**ATTACHMENT I**

**Comments from Federal Land Managers and EPA (with responses):**

**Including comments on the August 27, 2009 Public Hearing**

Description of Environmental Protection Agency (EPA) Comments on Connecticut's Draft  
Regional Haze State Implementation Plan (SIP) and Connecticut Department of Environmental  
Protection (CTDEP) Responses

**Figure 8.11: Annual Sulfur Dioxide (SO<sub>2</sub>) Emissions, by State**

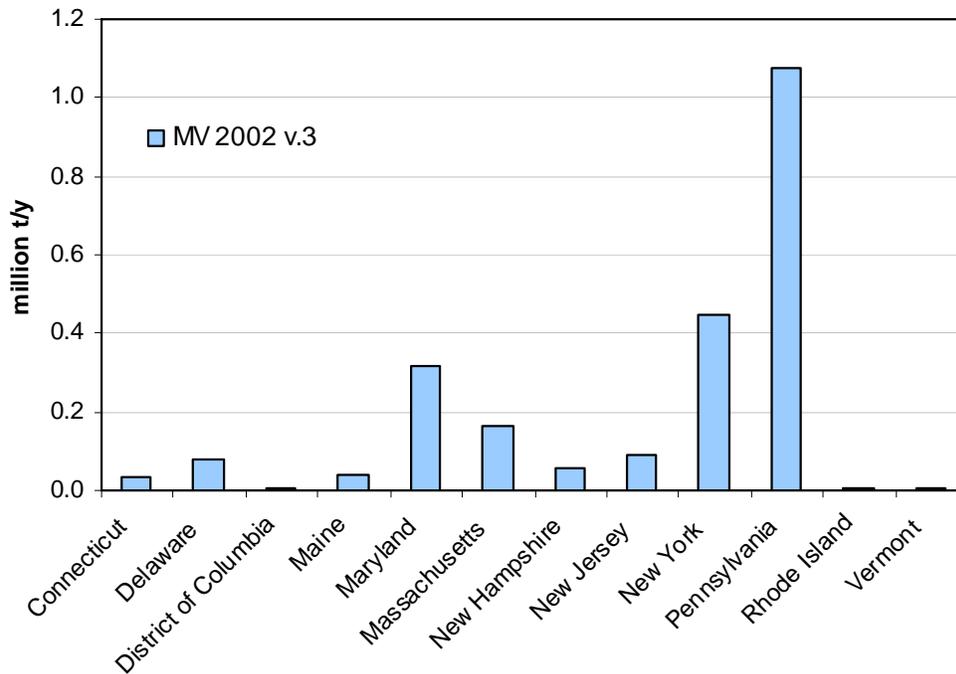
5) The reference cited for Figure 8.11 appears inaccurate. Please correct this reference.

*The reference cited for Figure 8.11 appears inaccurate. Please correct this reference.*

*In the second paragraph of Section 8.3.1, Connecticut states, "Most states in the region showed declines in annual SO<sub>2</sub> emissions through 2002 compared with those previous inventories." Connecticut should include the data that support this statement, refer to another document that contains the supporting data, or remove the statement.*

CTDEP has reorganized and revised the text after the first paragraph in Section 8.3.1, Sulfur Dioxide (SO<sub>2</sub>) as follows:

"Figure 8.11 shows SO<sub>2</sub> emissions in the MANE-VU states as extracted from the 2002 MANE-VU inventory (MARAMA, 2005).
